**Wildflower
Village Plan Area 1
Tuesday, October 18, 2016
Public Hearing**

Report Date:	Monday, October 10, 2016
Applicant:	Nathan Shipp, DAI Utah
Owner:	Sunrise 3, LLC; WFR 3, LLC, Easy Peasy LLC
Location:	1 mile west of Redwood Road; West and North of Harvest Hills
Major Street Access:	State Road 73, future: Redwood Road and Mountain View Corridor
Parcel Number(s) & Size:	58:021:0143, 157.137 acres 58:022:0133, 2.068 acres 58:021:0024, 4.50 acres Total: 163.185 acres (application describes 168.59)
Parcel Zoning:	PC
Adjacent Zoning:	RC, A, R-3, R-14, R-18
Current Use of Parcel:	Vacant
Adjacent Uses:	Residential, Vacant
Previous Meetings:	Gilead Rezone/Master Plan application submitted 2011; not finalized. PC and CC Hearings & Meetings on Rezone / CP, 2014 and 2015 PC Public Hearing on Village Plan 1, September 22, 2016
Previous Approvals:	Community Plan Approval, February 24, 2015
Land Use Authority:	Council
Type of Action:	Administrative
Future Routing:	None
Author:	Kimber Gabryszak, AICP

Author: Gordon Miner, City Engineer
Subject: Wildflower Village Plan
Date: September 8, 2016
Type of Item: Village Plan Approval

SECTION 11: Vehicular Plan

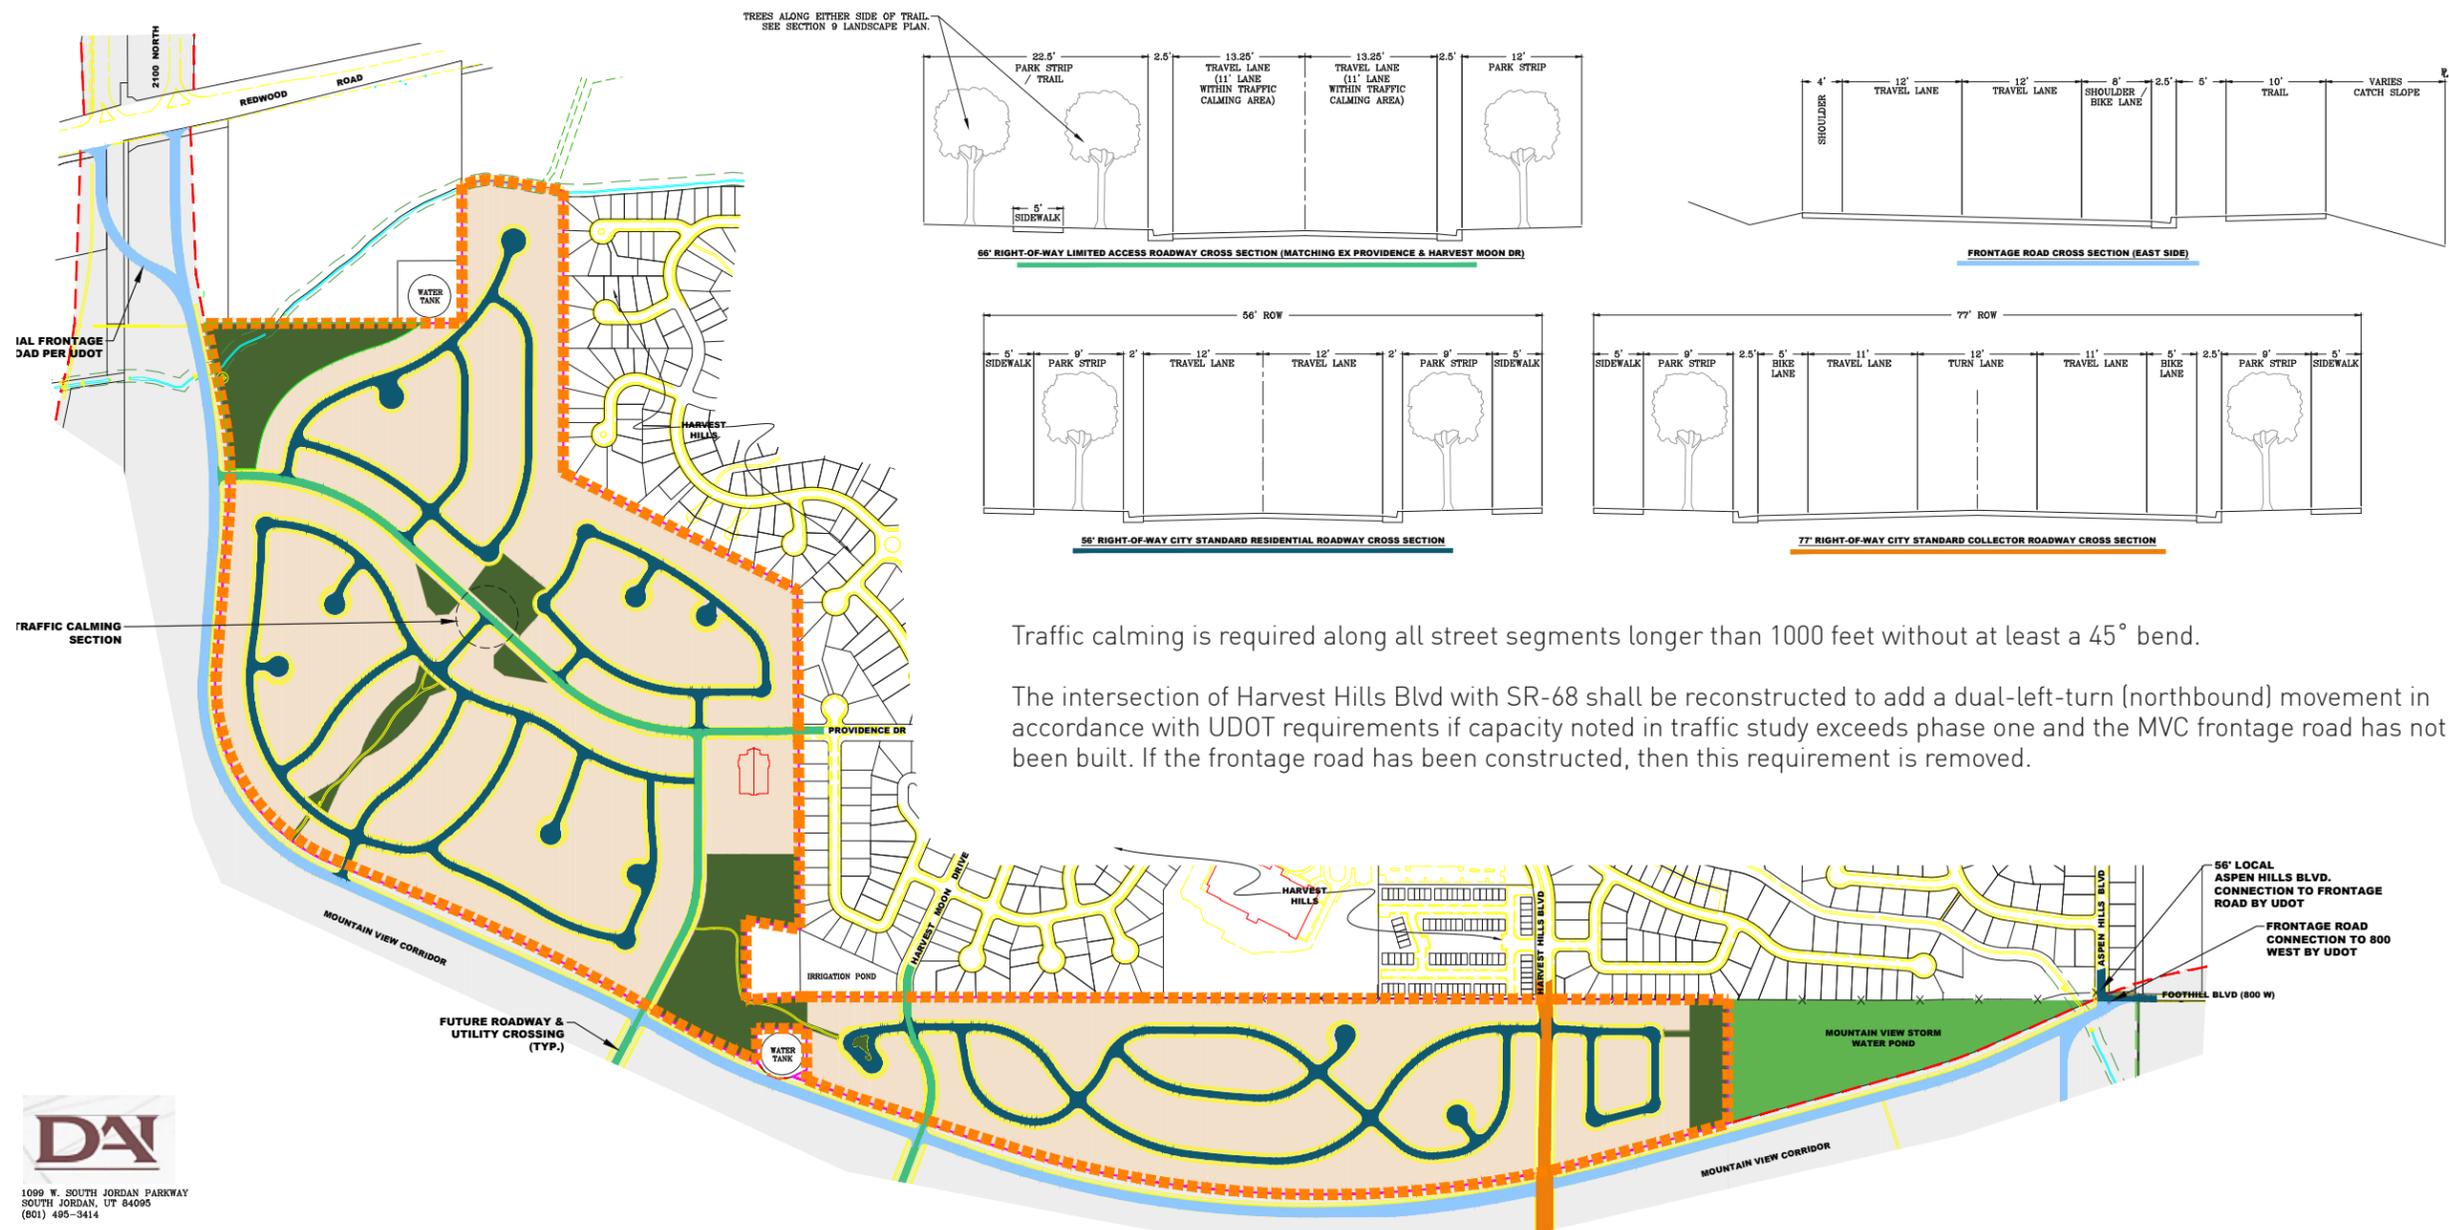
25. The Traffic Impact Study will be discussed and referenced on the Vehicular Plan sheet.
26. On the sheet titled "Vehicular Plan" indicate whether Wildflower will build Frontage Rd. If not, include a note that mentions the Frontage Rd. typical section is shown for illustrative purposes only and refer to UDOT for actual typical section.

BUILDER DIRECTIONAL SIGN

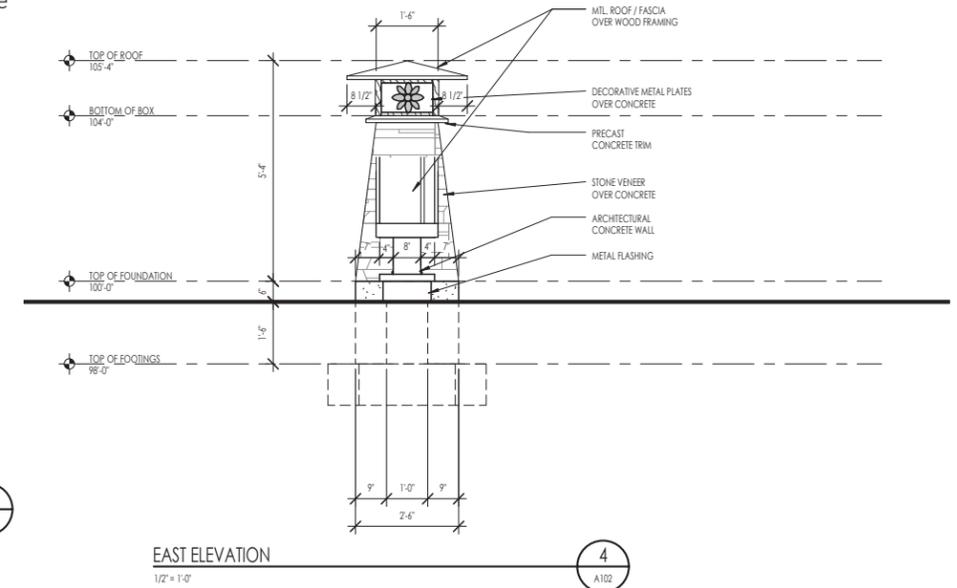
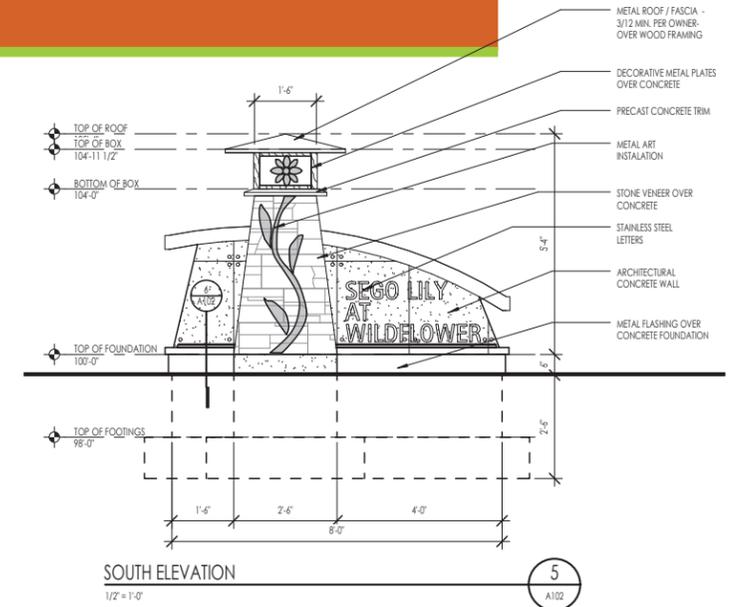
- a. Add a maximum number of development information signs that can be up at any one time so that not all predicted locations have signs at one time.
 - b. Clarify that the typical builder sign height graphic showing 12' is also referring to the maximum height.

SECTION 14c: Grading Plan

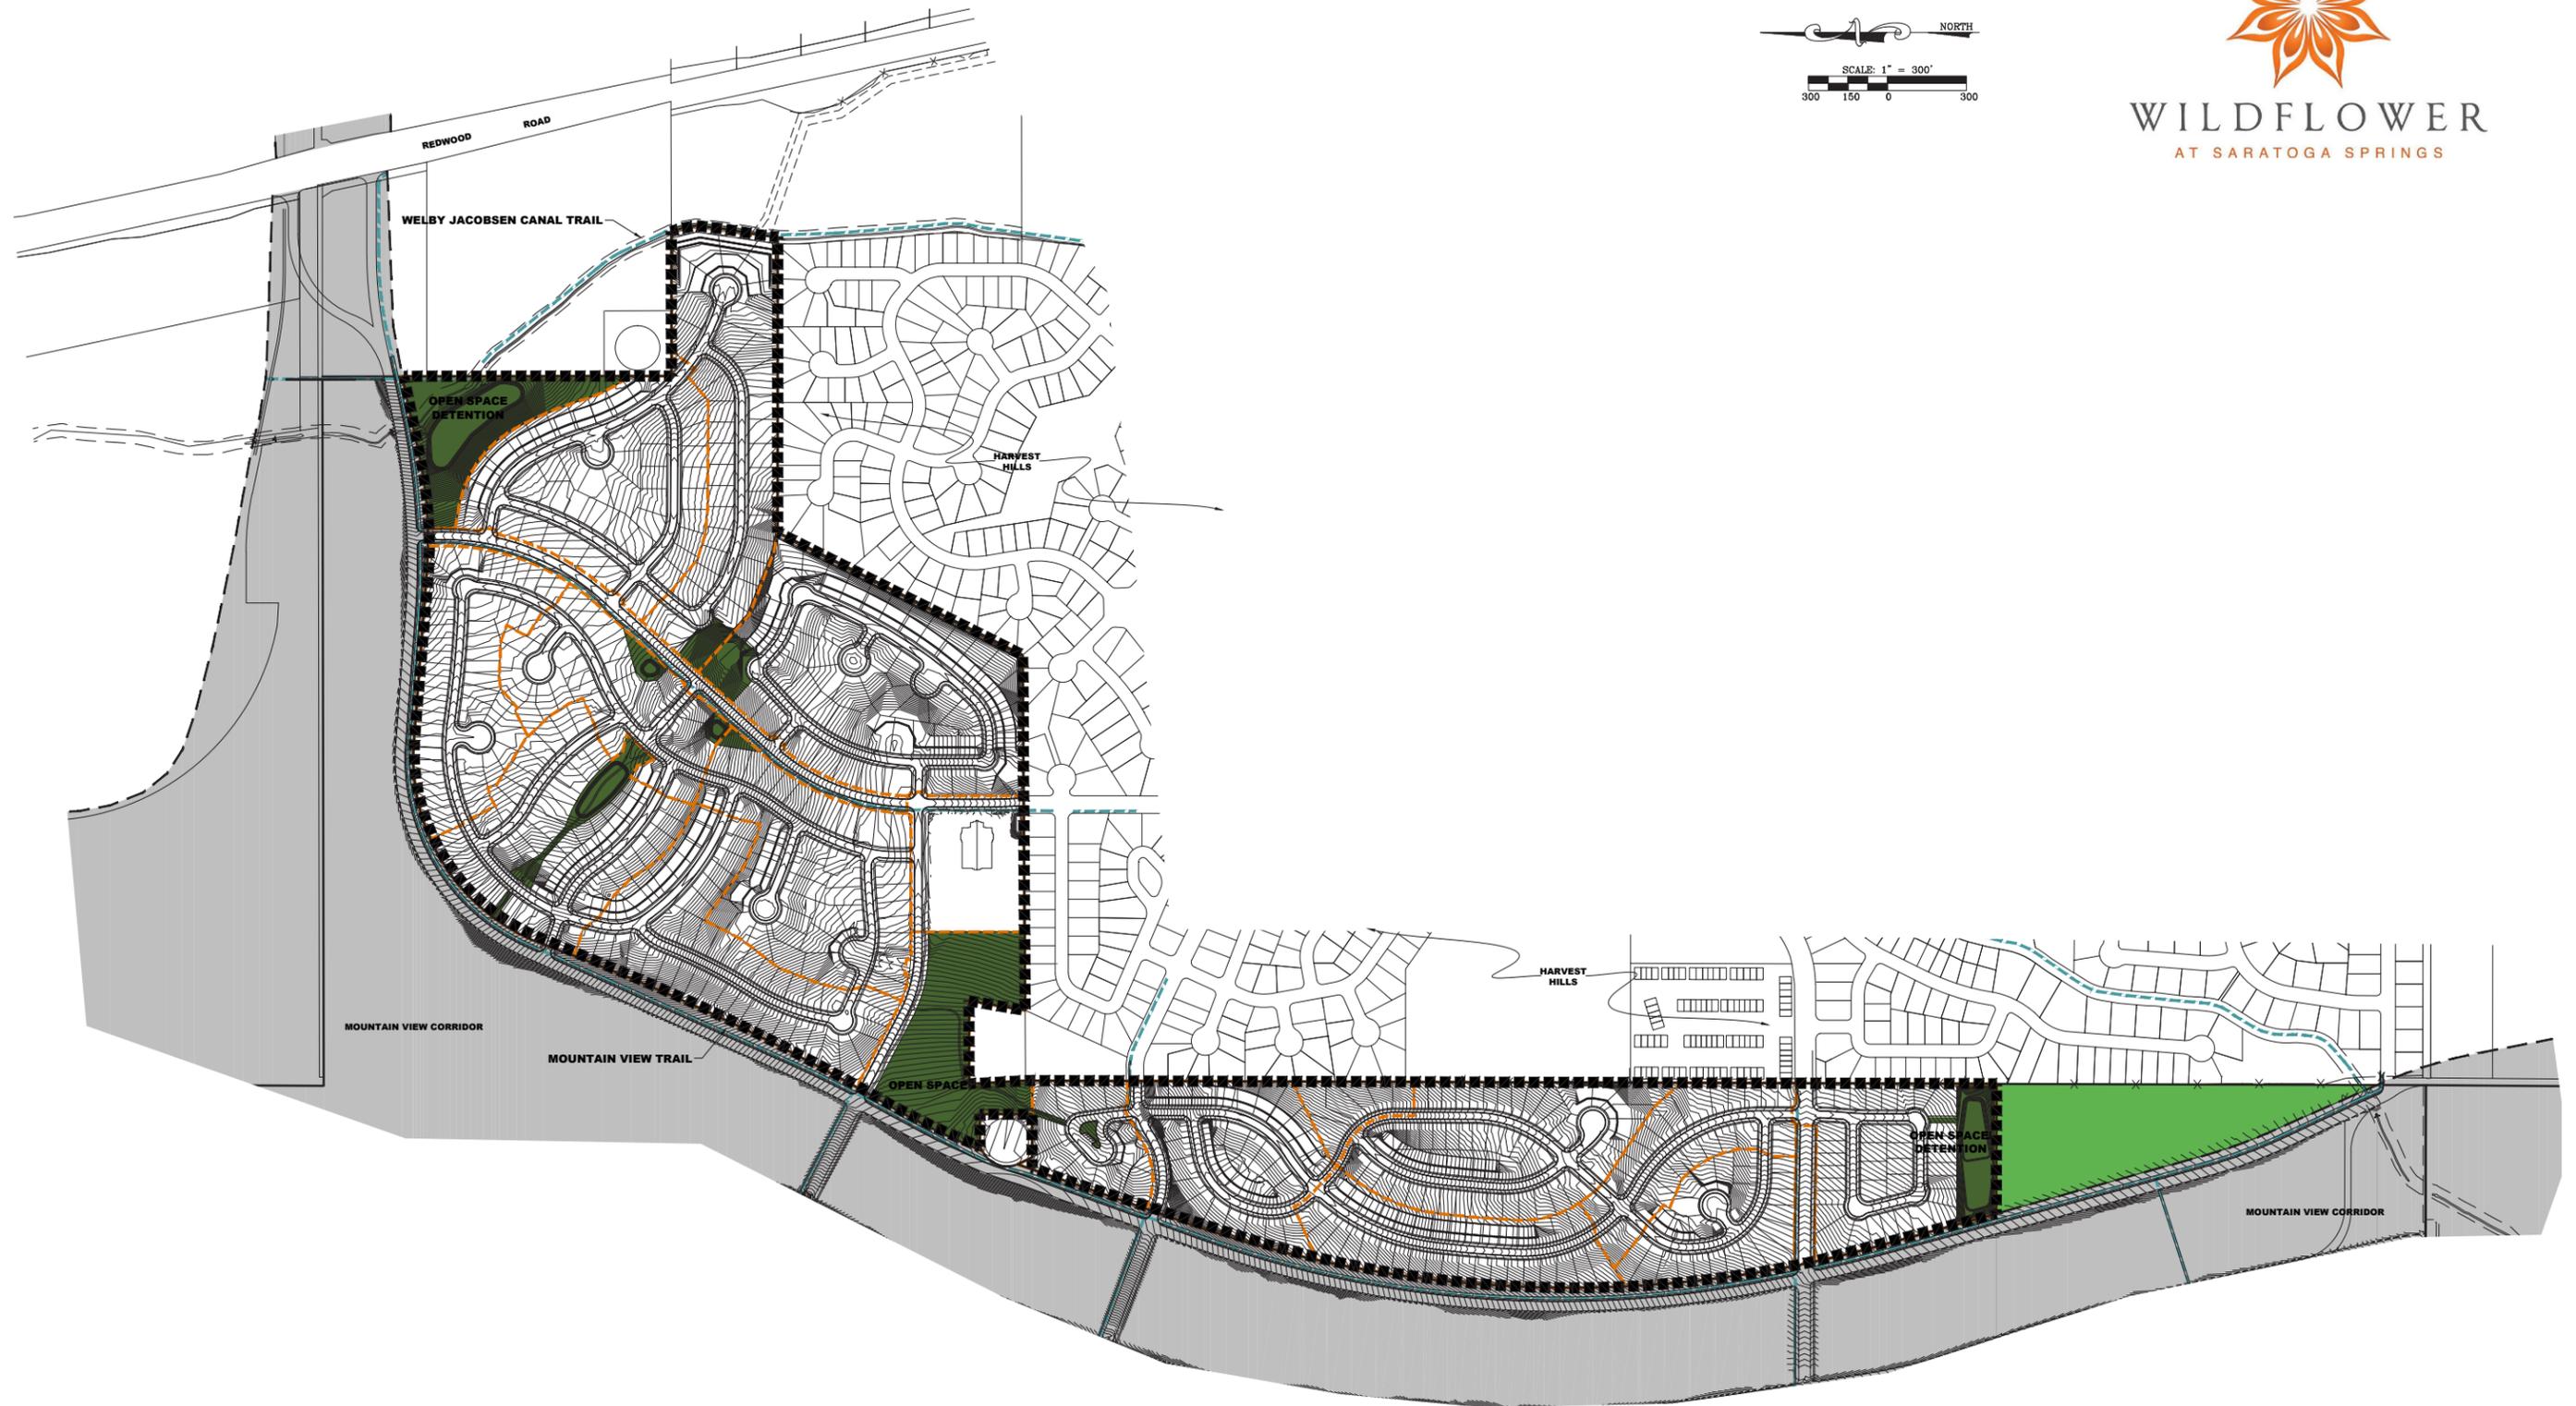
27. Provide the following note on the Grading Plan sheet: "The grading contours are for illustrative purposes only. All grading will be subject to the City's final plat engineering design acceptance process."

Open Space D Playground Concept

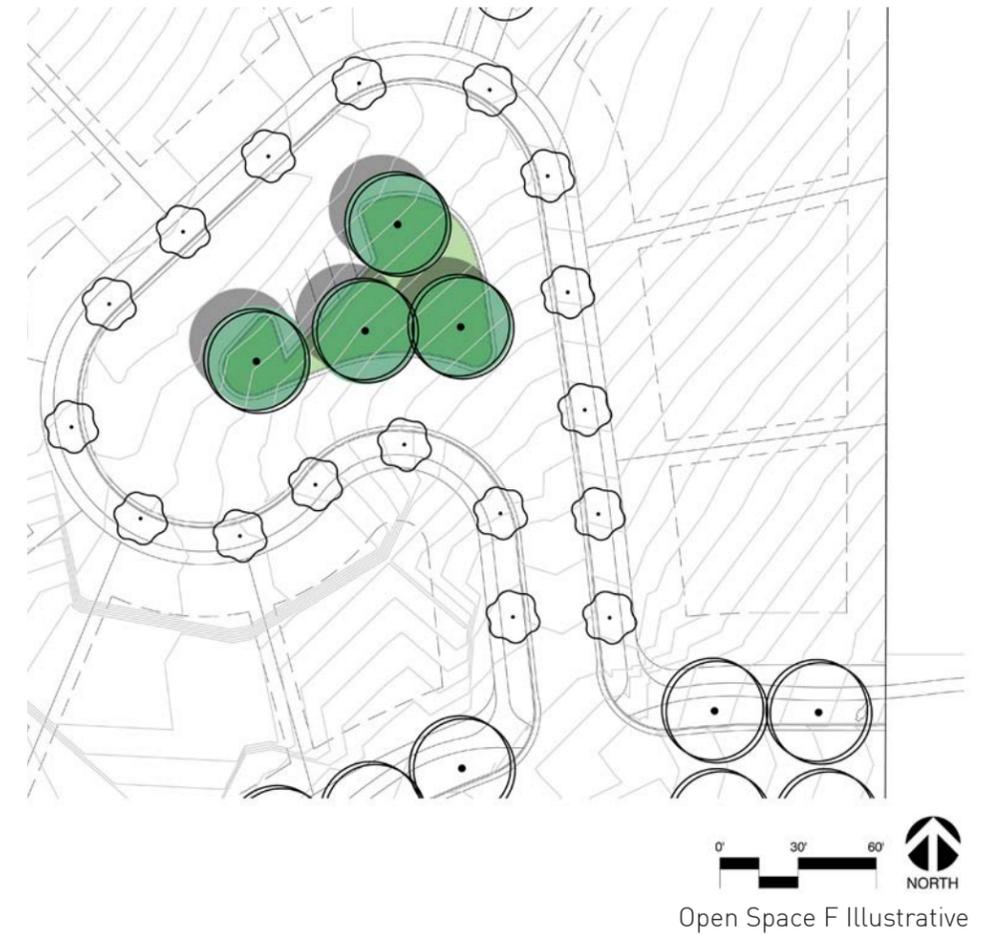
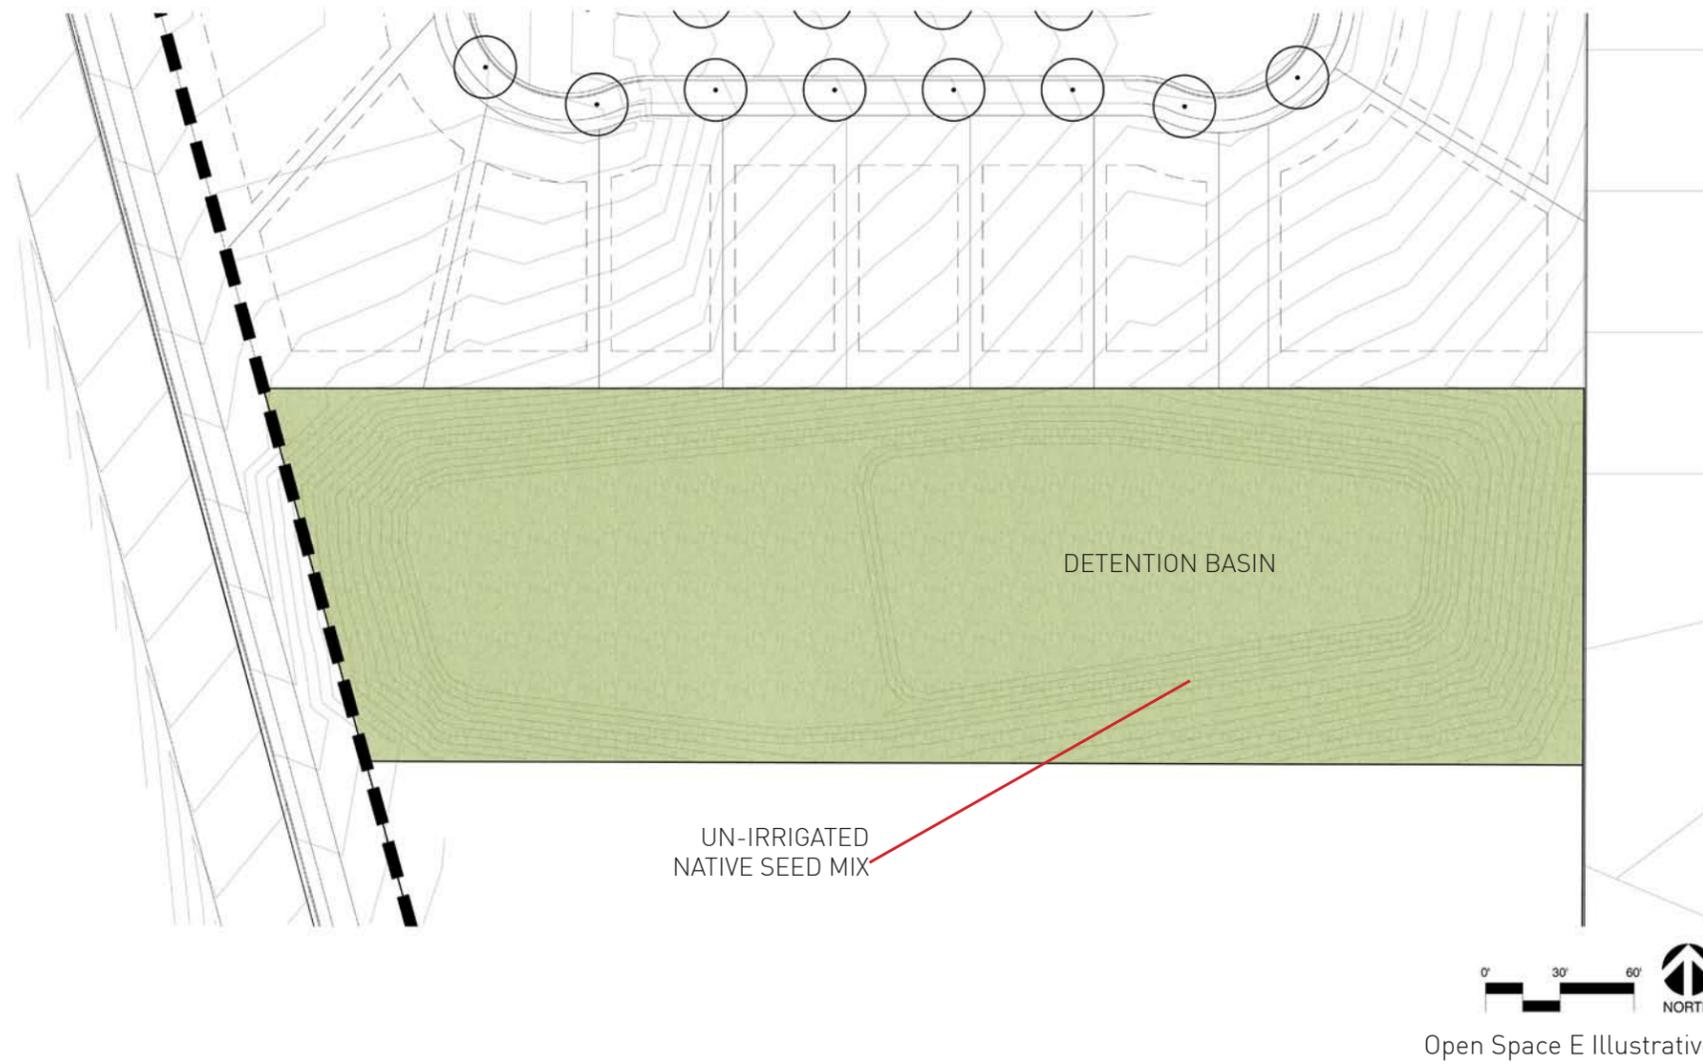
The applicants are requesting that the City accept ownership and maintenance of a “Public Community Park”, identified as Open Space D on page S14-12 of the Village Plan. The City Parks Department has reviewed the request, and has the following requirements should the City Council agree to accept this open space:

- The plans must be designed to City standards. Particularly:
 - Add an 8’ -10’ walkway to the playground. This is to help with service trucks and allow access for the fall material delivery trucks.
 - The trees must not be planted in turf and irrigated with turf. It is best for the trees to have separate landscaping and irrigation zones.
 - Plantings must comply with all City standards.
 - Mow strips are required along fences.
- More xeriscape options are needed.

- Specific manufacturers are required due to the excessive maintenance, repairs, and less than desired service from other manufacturers. Specifically, the requested manufacturers for the playground structures are Play World, Landscape Structures, or Gametime.
- No City maintenance will occur for signs, entry features, or other similar items.
- Public Works / Parks must be involved with the actual park construction plans of all City maintained areas during the plat approval to ensure compliance with City specifications
